Inspection and/or replacement of the valve push-rod assy., rocker arm left and rocker arm right for ROTAX® Engine Type 912 i, 912 and 914 (Series)

ATA System: 72-30-00 Cylinder head

MANDATORY

SERVICE BULLETIN

Fig. 1
Visual inspection

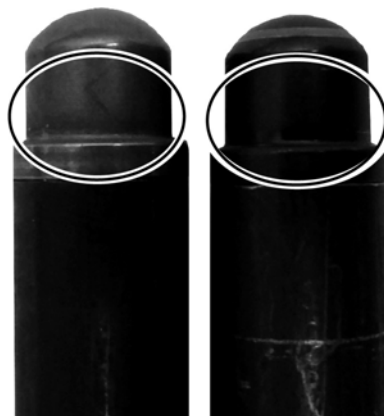
Perform visual inspection of all push-rod ball sockets on all cylinder.
 Check for color. See Fig. 1.

Color	Evaluation
Silver surface	Valve push-rod is OK. No further action required for this valve push-rod.
Black surface	Valve push-rod is NOT OK. See section. 3.1.3) Replacement of affected parts.

Fig. 2

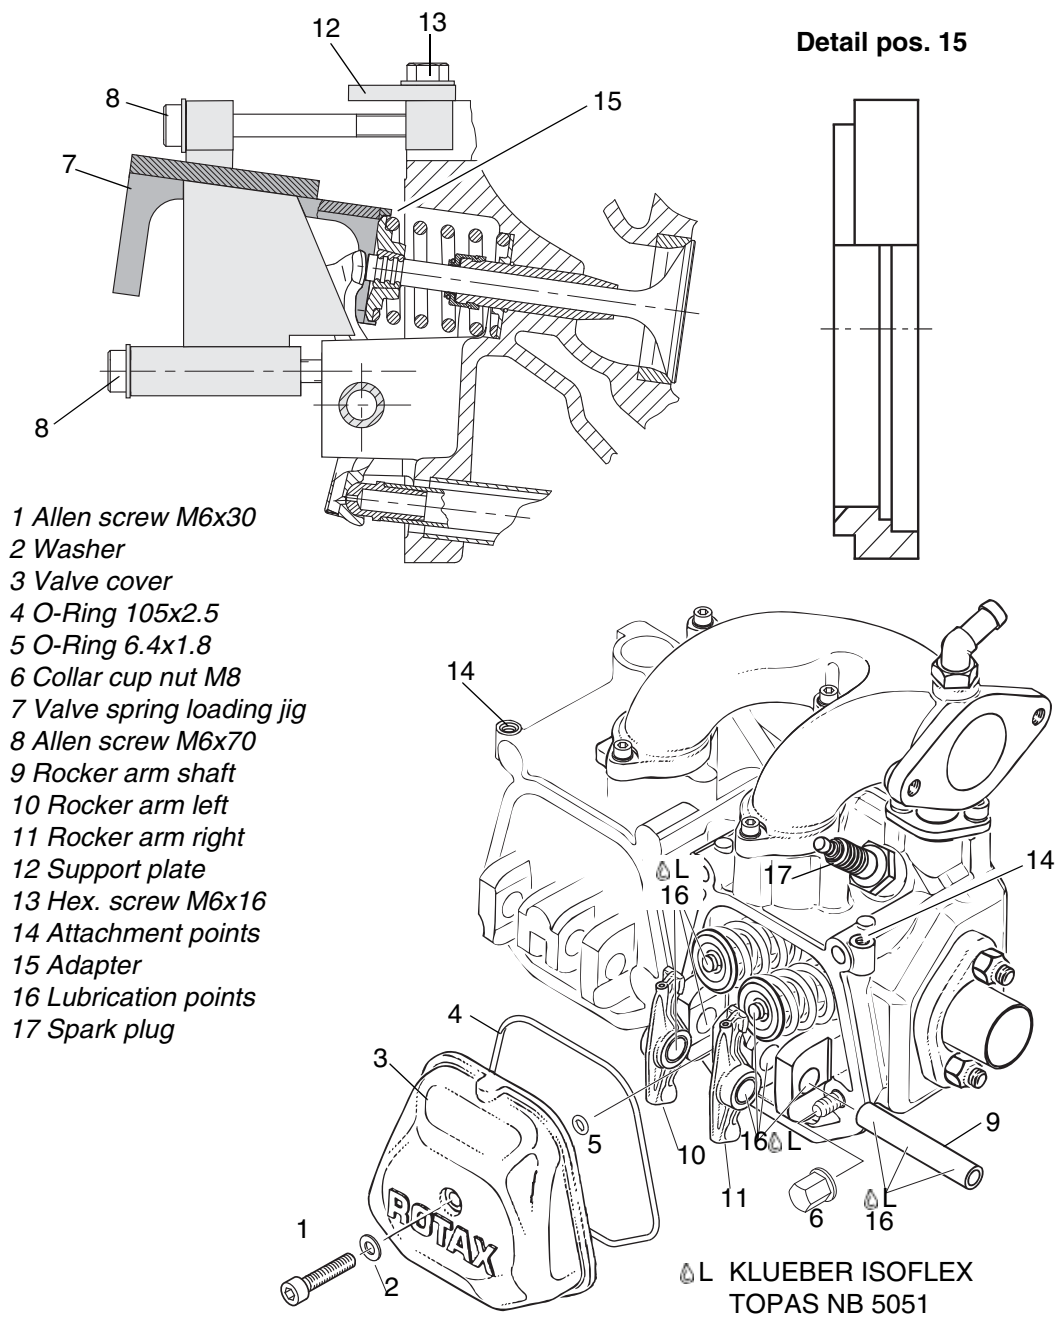
See Fig. 2.

Step	Procedure
1	Loosen Allen screw (1) M6x30 with washer (2) from valve cover (3), and remove it together with large and small O-rings (4) and (5).

See [Fig. 2](#) and [Fig. 3](#).

Step	Procedure
2	Turn crankshaft so that the respective piston is exactly on ignition top dead center. NOTE: Only when you have an Criterion B) Spare parts affected engine and only if engine is equipped with collar cap nuts M8 wrench size 13: Loosen the external collar cap nut (6) for easier disassembling the rocker arm shaft.

Step	Procedure
3	Attach the support plate (12) to the valve spring loading jig part no. 877387 (7) with 2 hex. screws (13) M6x16 at the attachment points (14) on the cylinder heads.
4	Put adapters (15) on the valve spring loading jig.
5	Attach the valve spring loading jig on cylinder head and support plate with 2 Allen screws (8) M6x70 and depress both valves with 3 turns.

Step	Procedure
6	This will relieve the pressure from both hydraulic tappets. Now the rocker arm shaft (9) may be easily pulled out. Lift out both rocker arms (10) and (11). NOTE: If you cannot pull out the rocker arm shaft easily, you will need to contact an ROTAX® Authorized Distributor for further action.
7	Replace all affected parts including push rods and rocker arms. See also Fig. 3.
8	Apply KLÜBER ISOFLEX TOPAS NB 5051 (16) on both push-rod ball sockets and contact areas of rocker arm and slide push-rod into the oil return tube (20).
9	Install rocker arm bushing into rocker arm left (10) and rocker arm right (11). Put oil on the rocker arm bushing.
10	Place rocker arm left (10) and rocker arm right (11) in cylinder head, apply KLÜBER ISOFLEX TOPAS NB 5051 (16) on rocker arm shaft (9) and insert it into its bearing support.
11	Loosen valve spring loading jig and support plate.
12	When removing the valve spring loading jig, make sure the adapter rings (15) do not jam on the valve spring retainer.

13	NOTE: Only when you have an Criterion B) Spare parts affected engine and only if engine is equipped with collar cap nuts M8 wrench size 13: Mount collar cap nut (6) according to latest Maintenance Manual Heavy or SI-912-025/SI-914-026/SI-912 i-010.
14	Lubricate all moving parts in the rocker arm space with engine oil or equivalent.
15	Clean the sealing surface of cylinder head and valve cover with a suitable lint-free cloth or equivalent.
16	Insert new O-ring (4) 105x2.5 and O-ring (5) 6.4x1.8 into the valve cover (3).
17	Fit valve cover.

Step	Procedure
18	Tighten the new Allen screw (1) M6x30 with washer (2) to 10 Nm (89 in.lb).
